L-89-133 10 CFR 50.59

Re: St. Lucie Unit 2 Docket No. 50-389 Report of 10 CFR 50.59 Plant Changes

> ST. LUCIE PLANT UNIT 2 REPORT OF CHANGES MADE UNDER THE PROVISIONS OF

FOR THE PERIOD ENDING OCTOBER 6, 1988

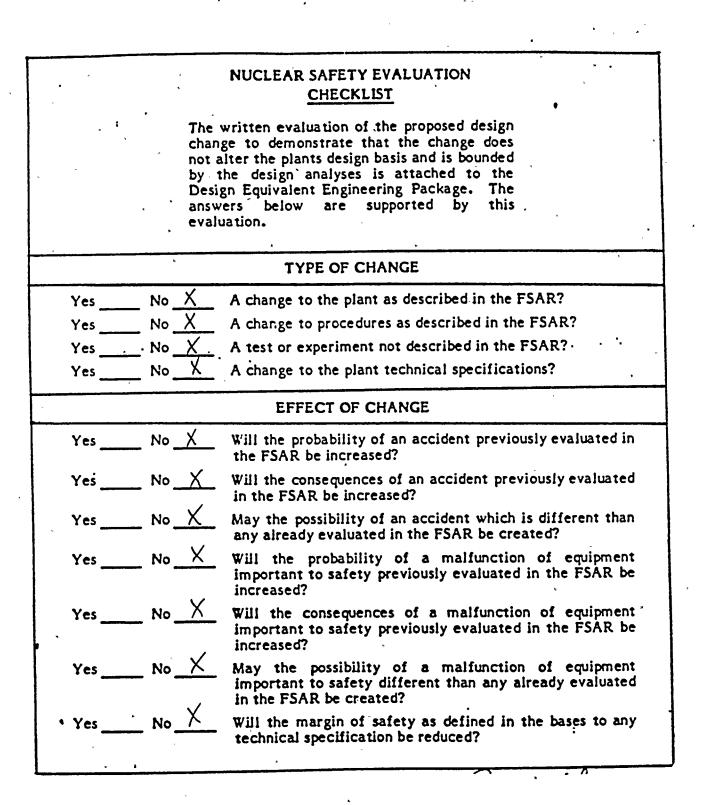
Model number B464 B-XNF shall be listed as B464BXNF. (See Attachment 4, Sheet 1)

The listing of the model number for each pressure switch shall change from B464-B-XNF to B464BXNF (Reference Ashcroft Bulletin 110, dated 4/80). (See Attachment 4, Sheet 1.)

- 4) The mounting location for pressure switches PS-29-4-1 and PS-29-4-2 shall change from IR 10-1B to IR 10-1A. (See Attachment 4, Sheet 1)
- 5) The information "QTY-2" and "TAG-PS-29-4-2" shall be deleted from EMDRAC Drawing #2998-13526. (See Attachment 4, Sheet 2)
